2.0 SITE CHARACTERISTICS

2.1S.1 Geography and Demography

Section 2.1 of the South Texas Project (STP) Units 3 and 4 COL FSAR incorporates by reference Section 2.1 of the certified Advanced Boiling-Water Reactor (ABWR) design control document (DCD) Revision 4, referenced in Title 10 of the *Code of Federal Regulations* (10 CFR) Part 52, Appendix A, with no departures. In addition, in COL FSAR Section 2.1S.1, the applicant provides site-specific information on site location and description to address COL License Information Item 2.3 as summarized below:

Figure 2.3S.2-1. Comparison of 1997, 1999, and 2000 Wind Direction Frequency Distributions.

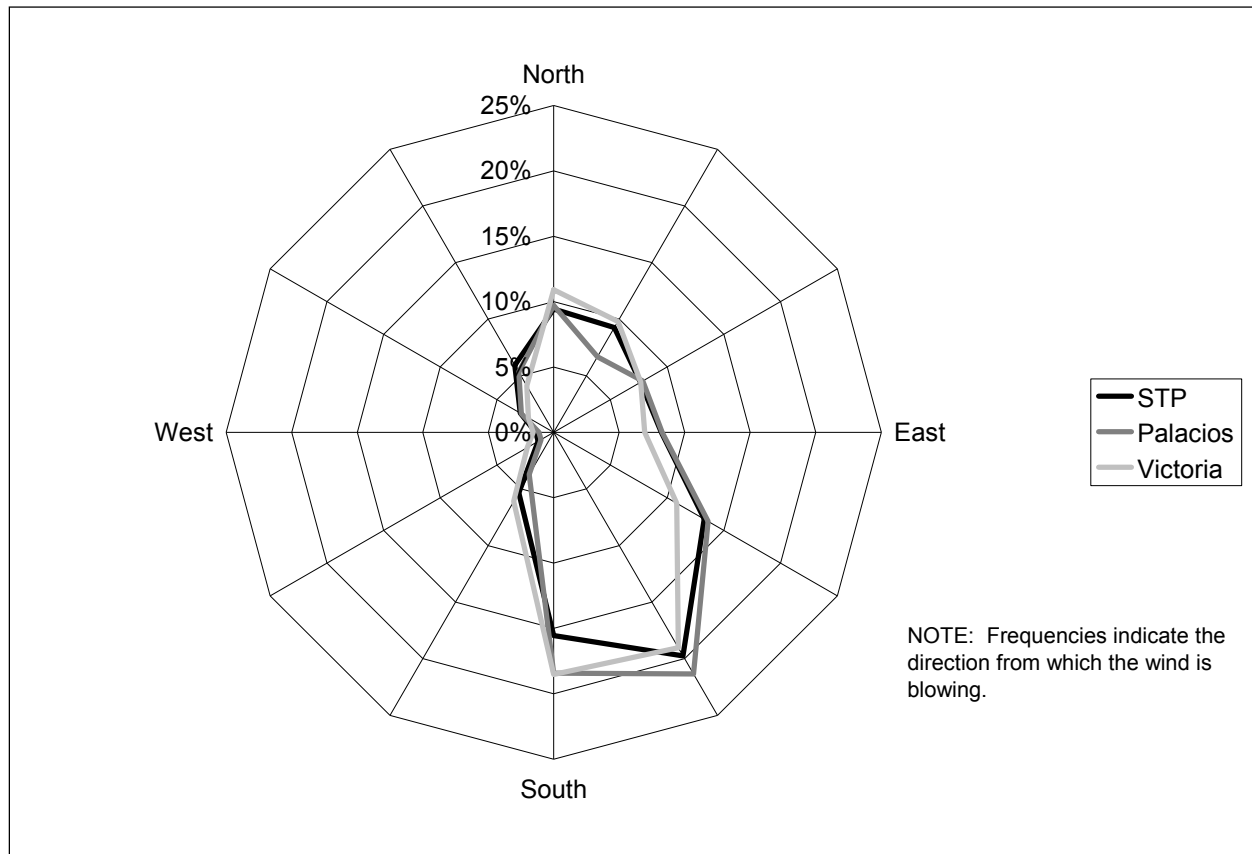
In order to confirm this hypothesis, the staff generated a comparison of annual wind direction frequencies among the STP, Palacios, and Victoria hourly data for the years 1997, 1999, and 2000. This comparison, shown in SER Figure 2.3S.2-1, indicates a similar distribution among all three sites. The staff also compared annual average wind speeds among all three sites for the same three-year time period. The staff found that the STP 10-meter level average wind speed of 4.1 m/s is consistent with the 6.1-meter level average wind speed of 4.1 m/s at Victoria but somewhat lower than the 5.0 m/s average wind speed recorded at Palacios. The staff issued **RAI 2.3.2-4a** requesting the applicant to justify not including meteorological data from Palacios in the review of average wind direction and wind speed conditions discussed in Revision 0 of FSAR Tier 2 Section 2.3S.2.2.1.

Figure 2.3S.3-3. STP Stability Class Frequency Distributions

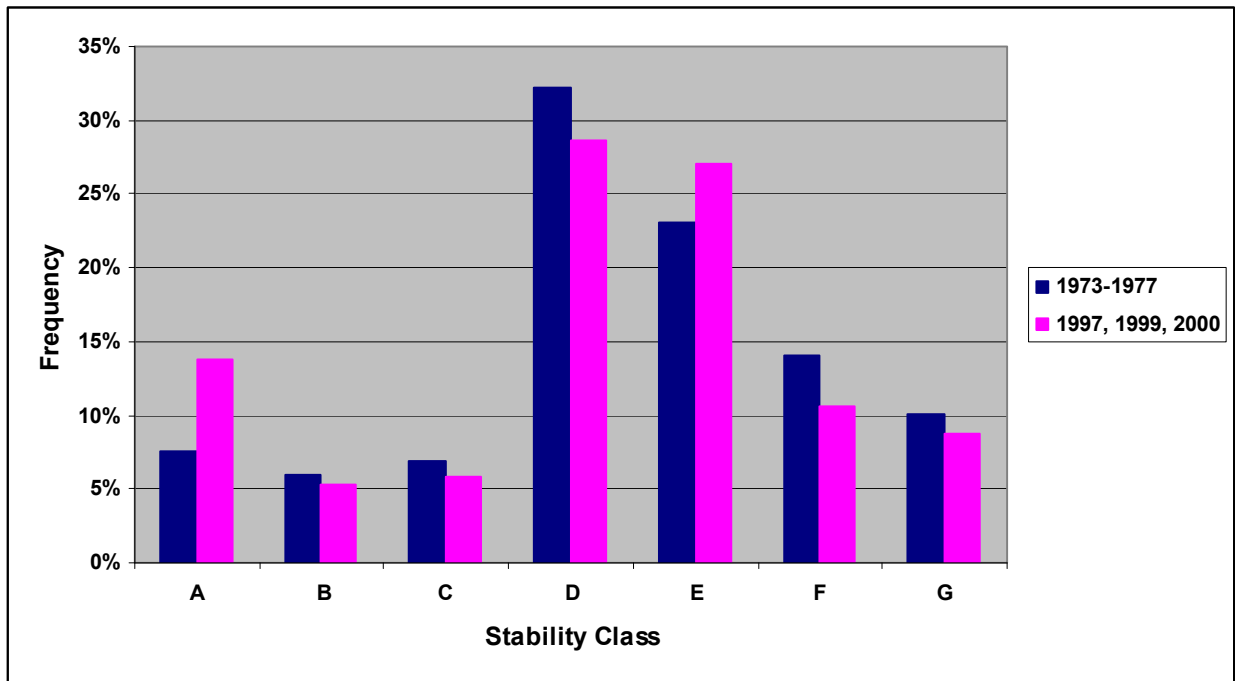
The stability class frequency distribution for both data sets in SER Figure 2.3S.3-3 also show reasonable agreement. Nonetheless, the staff issued **RAI 2.3.3-3** asking the applicant to explain the 6 percent frequency increase of onsite Stability Class A (extremely unstable) conditions from the original data set to the current data set (see SER Figure 2.3S.3-3).

The applicant's response to **RAI 2.3.3-3** (dated May 29, 2008) states that heat transfer from the MCR will increase the lower level ambient temperature, enhance thermal instability, and result in more unstable atmospheric conditions. Commercial operation of STP Units 1 and 2 commenced in August 1988 and June 1989, respectively. Therefore, the 1973 to 1977 data represent the STP Units 1 and 2 pre-operational conditions; the 1997, 1999, and 2000 data represent the STP Units 1 and 2 post-operational period. The MCR is located approximately 1 mile south-southwest of the MCR. SER Figure 2.3S.3-4 shows that Stability Class A increased primarily in the south-through-southwest wind direction sectors for the STP Units 1 and 2 post-operational period. Therefore, the applicant mainly attributes the 6 percent frequency increase of onsite Stability Class A to the thermal instability contributed by the MCR. The staff found this assessment reasonable and considers **RAI 2.3.3-3** closed.
